Addendum #5

**Bid Opportunity: 2025-RFT-001 Deep River Water
Treatment Plant Upgrades**

Option 2:

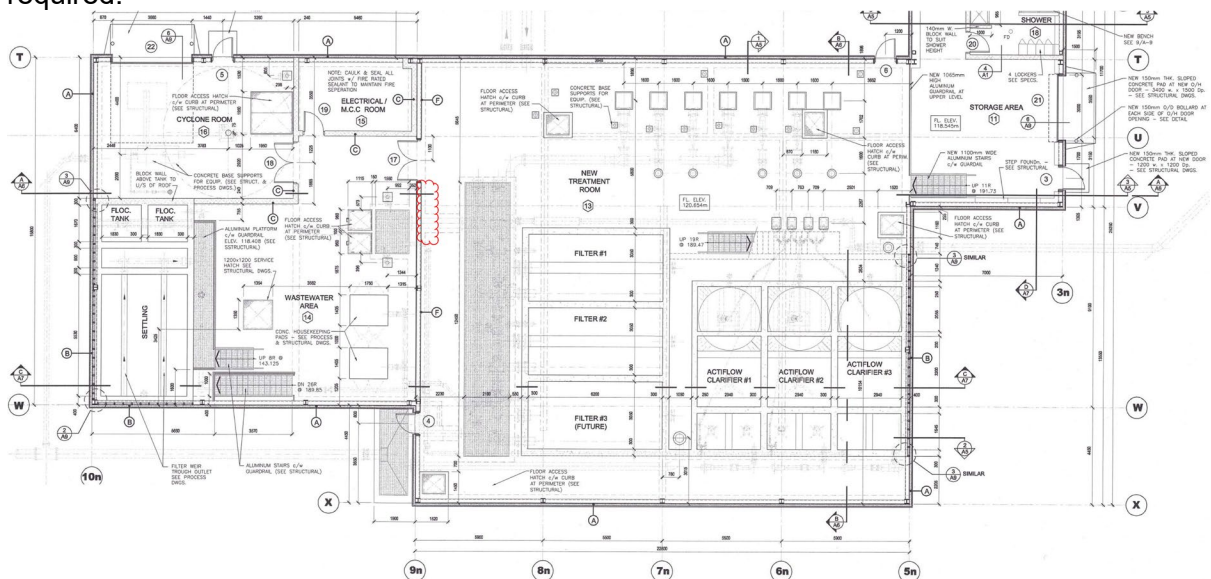
2.1 Question 1: During the site visit we had requested the drawings and procedure to replace the actiflo panel that controls the 3 filter beds.

It is being replaced in the same location as the existing panel with all piping entering the bottom of the cabinet.

We will have to keep a least one filter operational at all times and will need the info on how the engineers see this change over taking place.

- Install new main and secondary Actiflo control panels adjacent to filters (as shown below), relocating existing conduits, junction boxes, fire alarm trigger, etc. as required.

- Connect new Actiflo PLC control panels to power.
- Perform SAT of the programming of the new Actiflo PLC panels.
- Run control/power wiring from new Actiflo PLC controls panels to Actiflos.
- Connect control/power wiring to each Actiflo's instruments and equipment motors sequentially, only taking one Actiflo offline at a time.
- A maximum full plant shutdown of two (2) hours shall be permitted to allow the contractor to:
 - o Disconnect power from the existing/old Actiflo PLC panel.
- Remove and disposed of the existing/old Actiflo PLC panel and redundant instrument/equipment wiring.
